Executive Director's Recommendation

Commission Meeting: February 2, 2017

PROJECT Fence Replacement – Phase 1 White House Complex 1600 Pennsylvania Avenue, NW Washington, DC	NCPC FILE NUMBER 7776
SUBMITTED BY United States Department of the Interior National Park Service	NCPC MAP FILE NUMBER 1.31(38.40)44488
REVIEW AUTHORITY Federal Projects in the District per 40 U.S.C. § 8722(b)(1) and (d)	APPLICANT'S REQUEST Approval of final site development plans
	PROPOSED ACTION Approve final site development plans with comments
	ACTION ITEM TYPE Staff Presentation

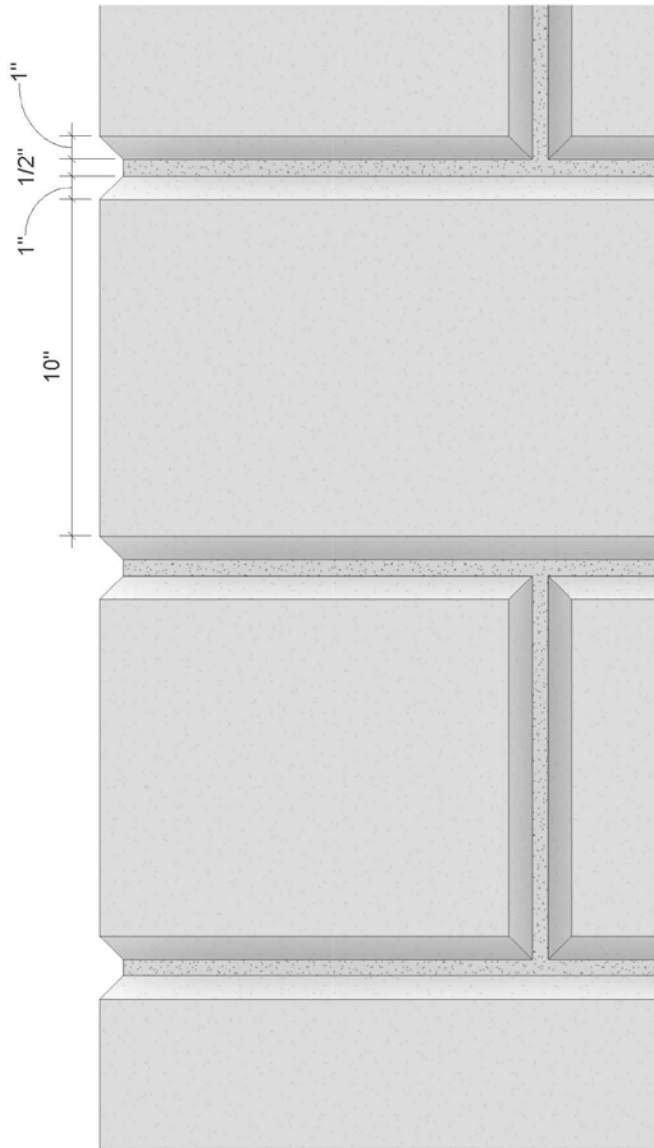
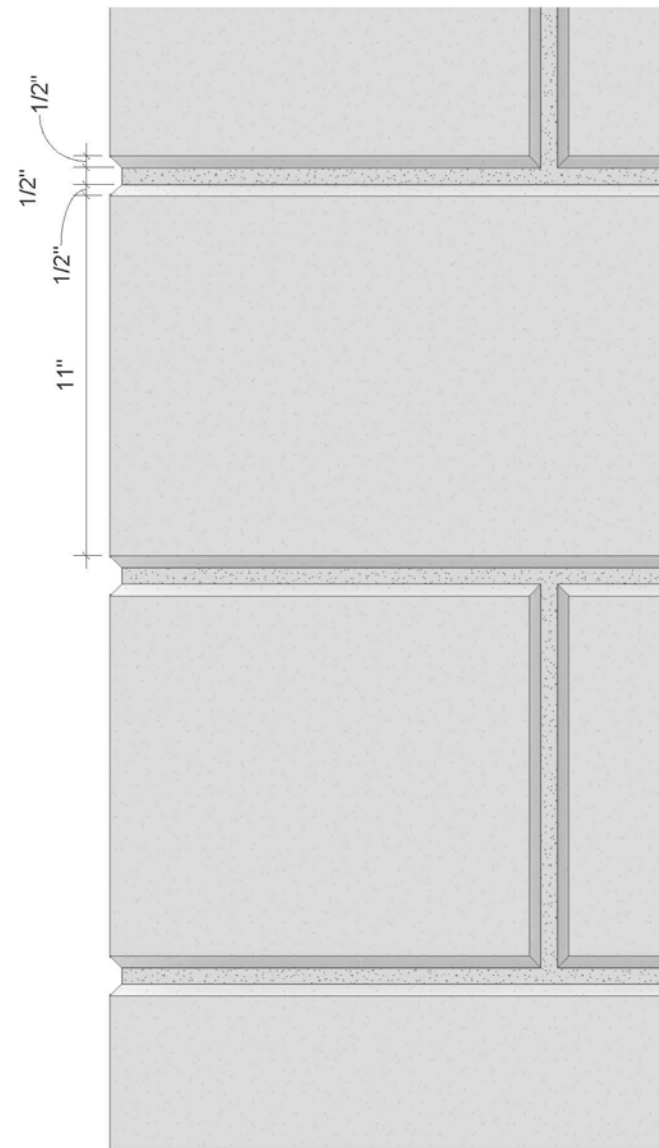
As noted previously, the existing stone piers would be increased in scale to accommodate the new fence height. Piers are generally located at fence corners, and they are used to frame vehicular entrances to the White House grounds. Along Pennsylvania Avenue, piers also frame the pedestrian entrances at both end of the circular driveway. Given their large size and massing, at preliminary review the Commission requested the applicant consider reducing the size of the piers, where feasible. In response, the width of the piers has been reduced from 4'-0" feet to 3'-9" feet. The pier "cap" which projects above the fence, and pier base have each been reduced 2" in height. In addition, the pier joints have been minimized. In total, staff believes these adjustments have appropriately reduced the scale of the piers while preserving their overall proportions.

At preliminary review, the Commission further requested the applicant consider eliminating piers from the pedestrian gates as a way to reduce the massing of these large-scale features along the fence. In response, the applicant has revised the design to eliminate the piers from the pedestrian gates. Staff supports this change as it opens up views to the White House grounds and allows the vehicular entrances to stand distinct from the pedestrian gates.

Pedestrian Gate
Pennsylvania Ave

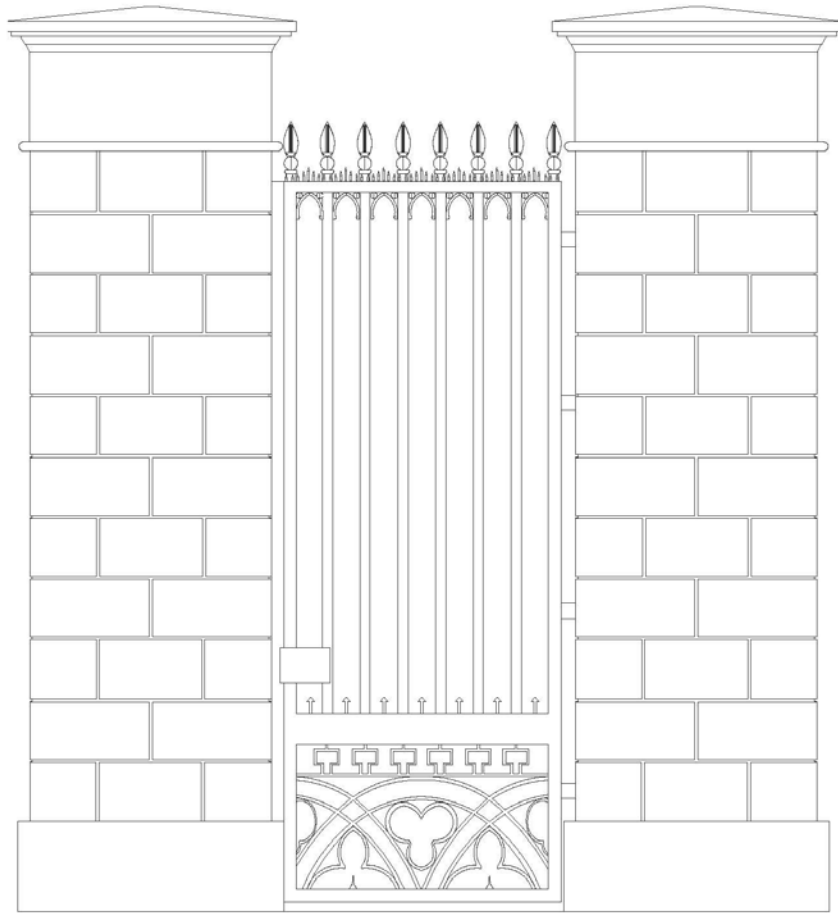
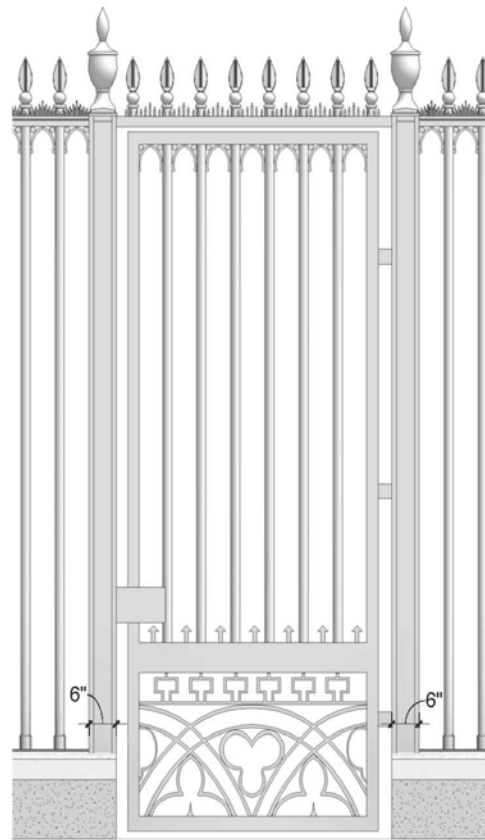
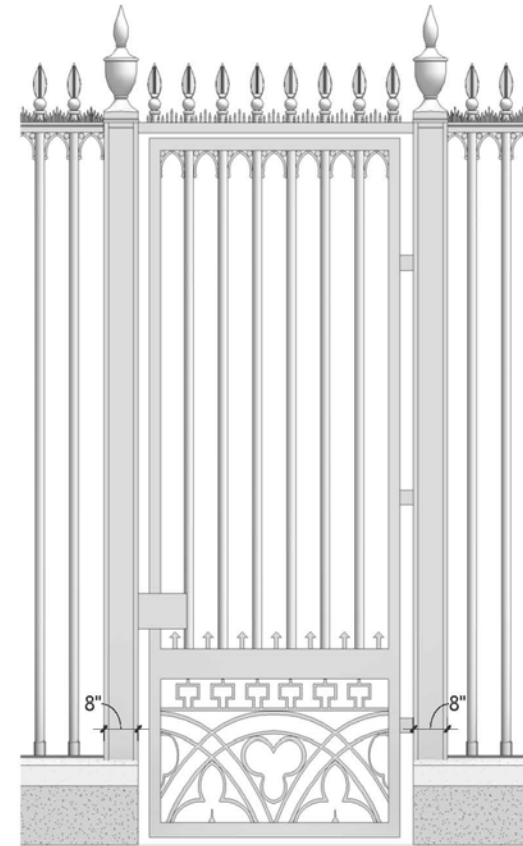
vertical pickets. Because a solid base is not required for structural purposes, a more transparent design can be utilized. In this case, simple vertical pickets appear preferable to the more ornate trefoil pattern for the pedestrian gates. Staff therefore recommends the **Commission support the NPS and USSS preferred design for the vehicular gates along Pennsylvania Avenue, in conjunction with the vertical picket concept for the adjacent pedestrian gates, as they best balance design with maintenance and operational needs.** Staff notes that the Commission of Fine Arts also approved this recommendation at their January 23, 2017 meeting.

Supports the NPS and USSS preferred design for the vehicular gates along Pennsylvania Avenue, in conjunction with the vertical picket option for the adjacent pedestrian gates, as they best balance design with maintenance and operational needs.

Option 1: Crash Rated Gate

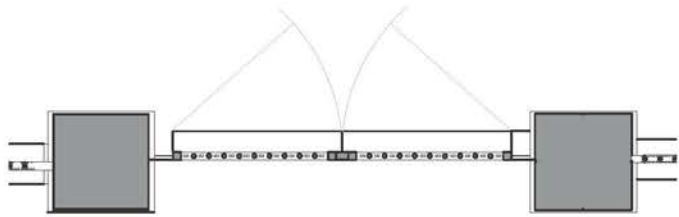
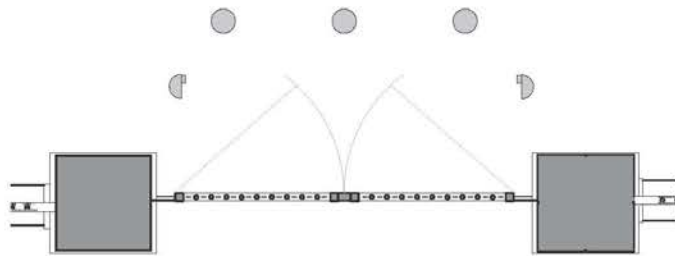
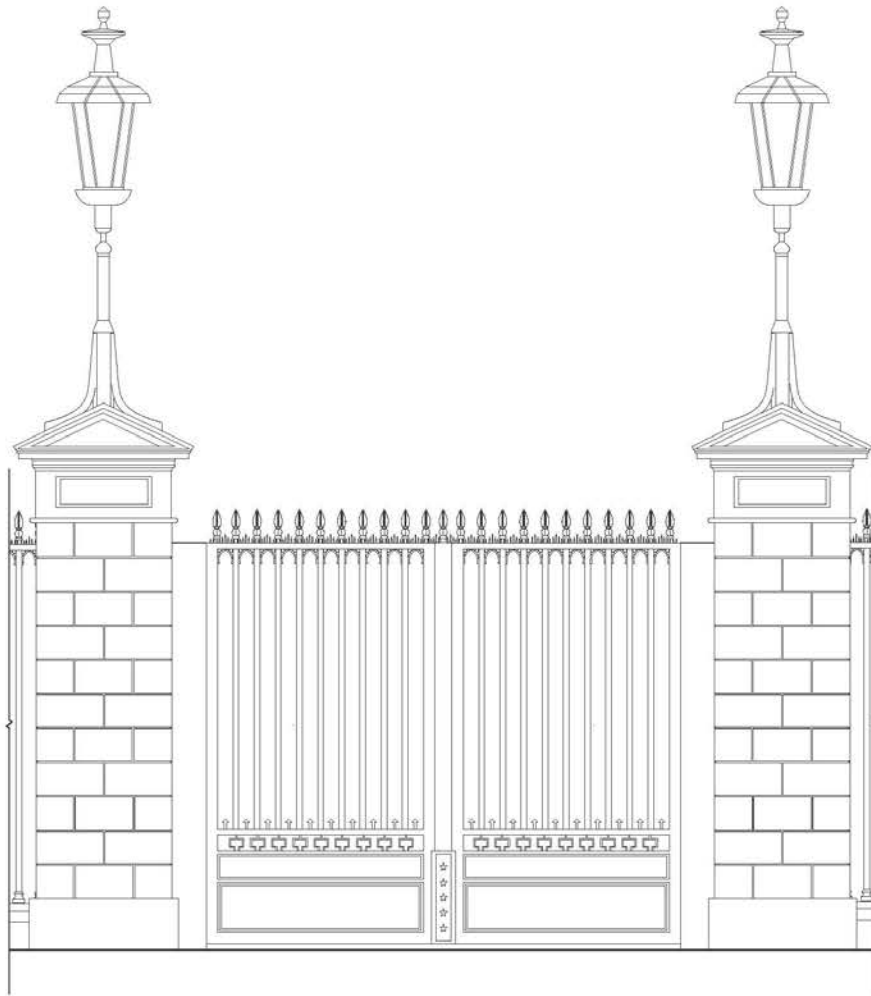
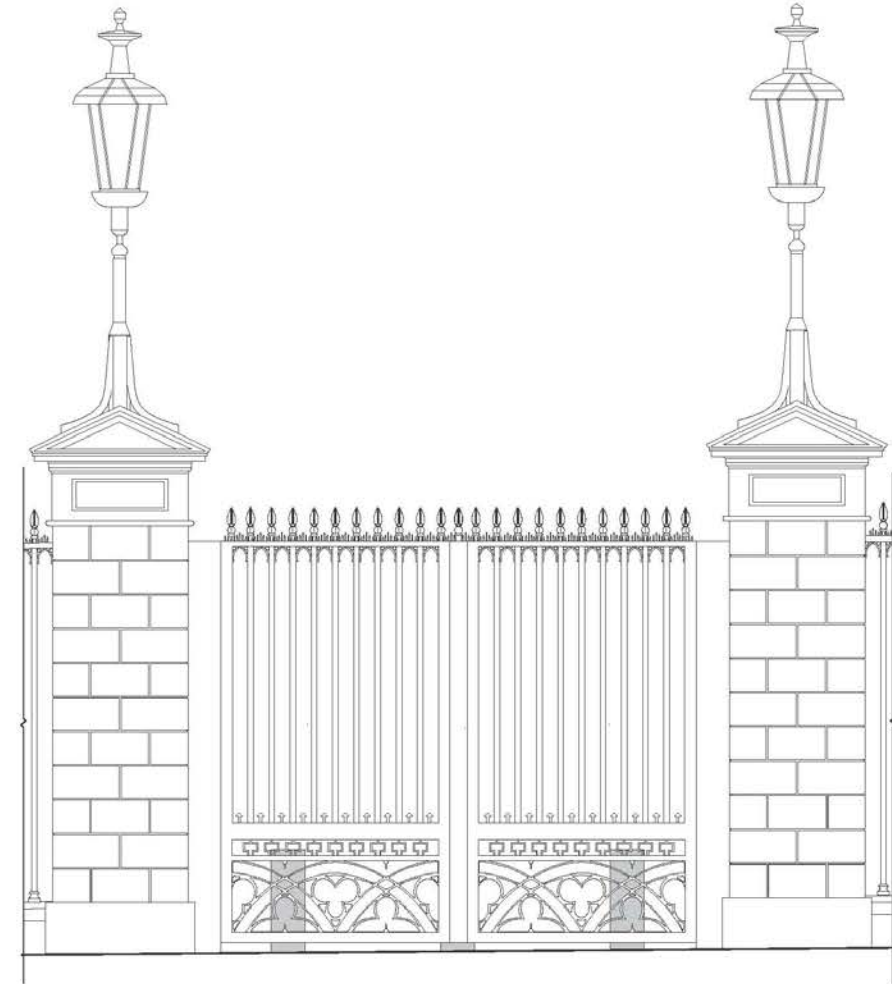
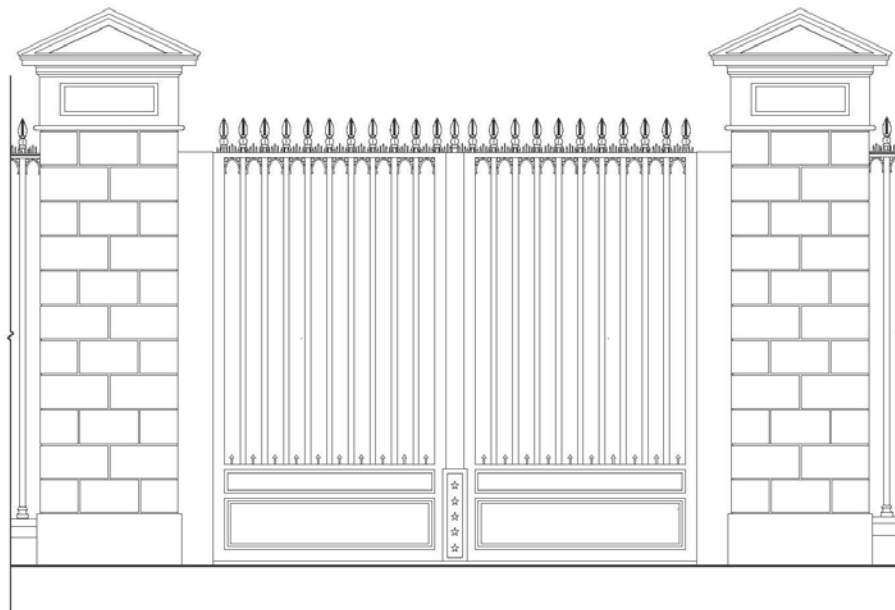
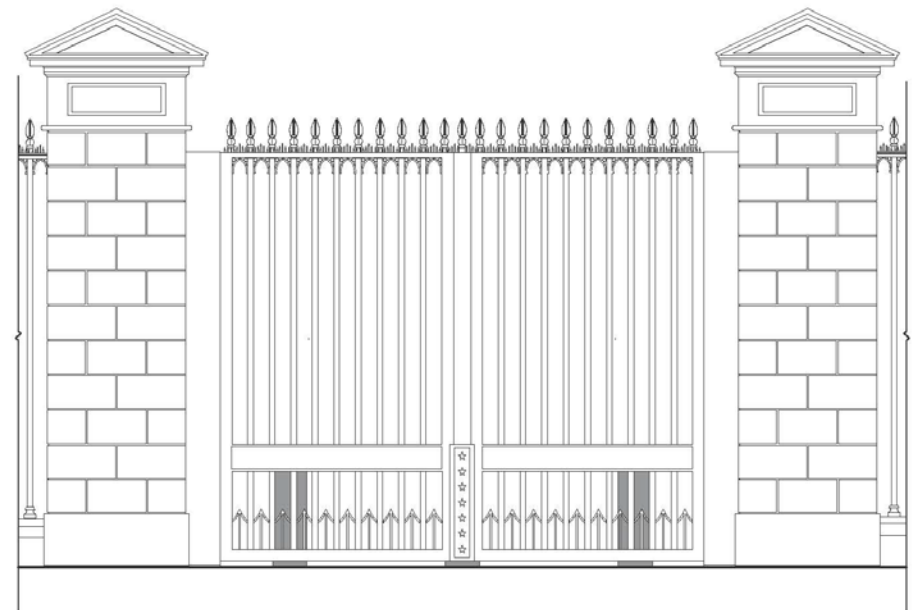
The non-crash rated option includes decorative metal scrolling, but bollards are required at the inside of the gate. The crash-rated gate includes a solid base, but no bollards are necessary. As such, the crash-rated vehicular gate with a solid base is the applicant's preferred design as it eliminates the need for bollards and the associated equipment and maintenance. Several designs were also considered for the adjacent pedestrian gates, including a solid base, arched trefoil, and
